Access Compliance Report

Public Rights-of-Way

(Curb Ramps)

Intersection ID: 11255	Main Street: ATTABERRY_DR	Cross Street: MATHESON_AV	Location:	N
ADA ID: 4D6677950331	Ramp Type: PerpDiag	Initial Pass/Fail: Fail	Overall Compliance: No	Severity Score: 33.75
Codes/Mitigation Info/Possible Solution		Field Measurements/Component Compliance

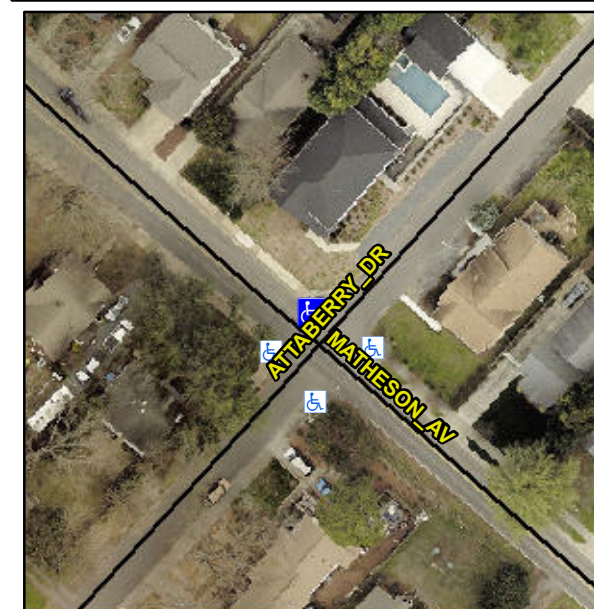
Not Found, R304.5.1, R304.5.3

Compliance	Description	Data	Compliance	Description	Data
N/A	Ramp Length (in)	60.0	Yes	Ramp Slope (%)	7.9
No	Ramp Width (in)	43.0	No	Ramp XSlope (%)	7.9
N/A	Flare Type LT	N/A	N/A	Flare Type RT	N/A
N/A	Flare Slope LT (%)	N/A	N/A	Flare Slope RT (%)	N/A
N/A	Flare Traversable LT?	N/A	N/A	Flare Traversable RT?	N/A
N/A	Landing Length (in)	N/A	N/A	DWS Provided?	N/A
N/A	Landing Width (in)	N/A	N/A	DWS Contrast?	N/A
N/A	Landing Slope (%)	N/A	N/A	DWS Length (in)	N/A
N/A	Landing X Slope (%)	N/A	N/A	DWS Full Width?	N/A
N/A	Landing Curb? (Y/N)	N/A	N/A	DWS Offset (in)	N/A
N/A	Shared Landing?	N/A			
N/A	Gutter Ponding?	N/A	N/A	Gutter Slope (%)	N/A
N/A	Gutter Lip Ht (in)	N/A	N/A	Gutter X Slope (%)	N/A
N/A	Painted X Walk1?	No	N/A	Painted X Walk2?	No
	X Walk 1 Direction	To SW		X Walk 2 Direction	To SE
N/A	X Walk 1 Width (in)	N/A	N/A	X Walk 2 Width (in)	N/A
	X Walk 1 Slope (%)	5.7		X Walk 2 Slope (%)	1.0
	X Walk 1 X Slope (%)	2.6		X Walk 2 X Slope (%)	8.0

N/A	Ramp inside XWalk1?	N/A	N/A	Ramp inside XWalk2?	N/A
	Road Slope (%)	5.2	N/A	Clear Space?	N/A
	Road X Slope (%)	6.3	N/A	Clear Space to XWalk (in)	N/A
N/A	Any Obstructions?	N/A	N/A	Storm Grate/Utility Hazard?	N/A
	Obstruction Type			Storm Grate/Utility Type	
		N/A			N/A
		Yes		Surface Condition? (G/P)	Good

Remove & Replace Curb Ramp With Two New Directional Ramps or Equivalent.
